MONTPELIER DEVELOPMENT REVIEW BOARD REPORT

SKETCH PLAN SUBDIVISION REVIEW

Applicant: Eyrich Stauffer

Address: 81 North Street

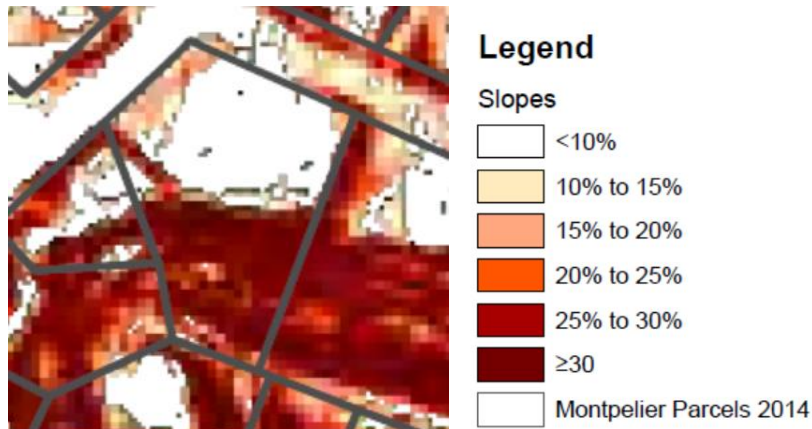
- b. Has significantly less than 60% coverage.
 - (1) **Per the Subdivision attachment, there’s roughly 1,100 SF of impervious surface.**
 - (2) **Staff’s estimate, counting the driveway, is closer to 2,400 SF of impervious surface.**

Staff Comment: Applicant needs to confirm impervious cover and buildable area in the Final Subdivision Application, and make sure setbacks are delineated for Lot 2 on the Final Plan.

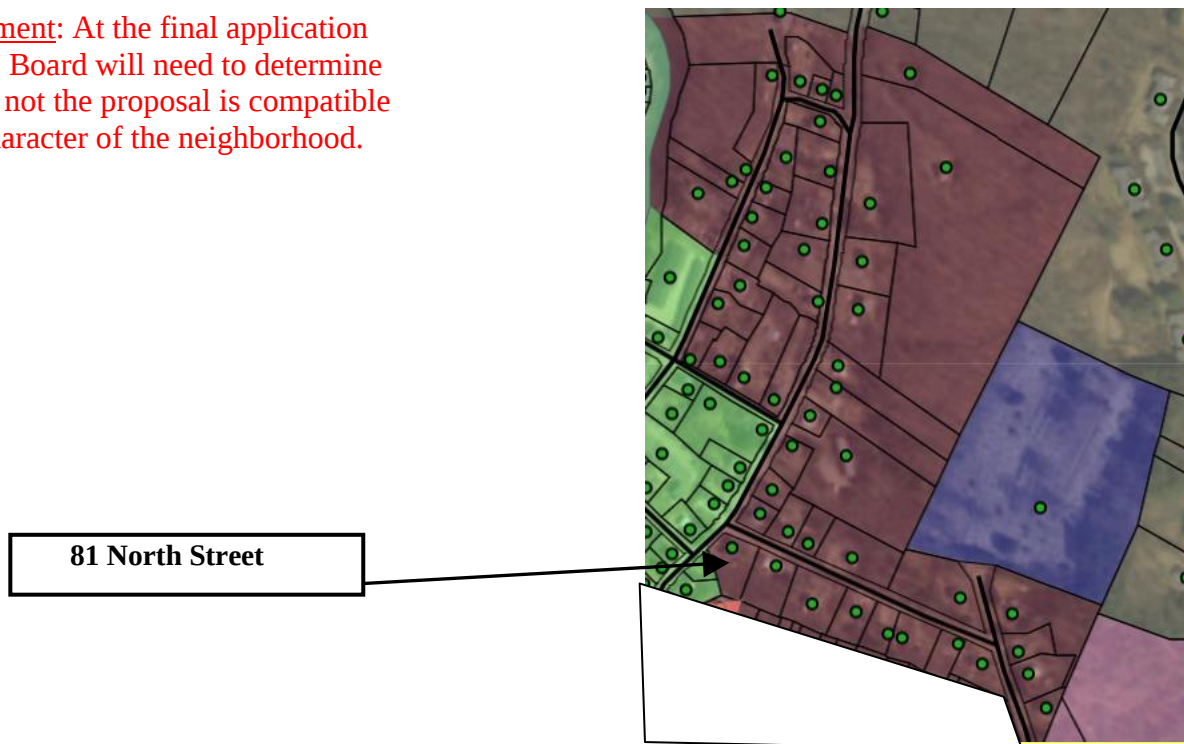
- i. In this developed neighborhood, all powerlines are currently above-ground, with the line along Ewing Street crossing over the road half-way down the Ewing St. frontage (see image below).

- ii. **Given the current physical location of the power lines, it seems sensible for Applicant to reach out to the local service provider to determine whether power for Lot 2 could be run underground from pole on the eastern boundary, and whether the power company would require a new pole (due to age of the current one) to do so.**
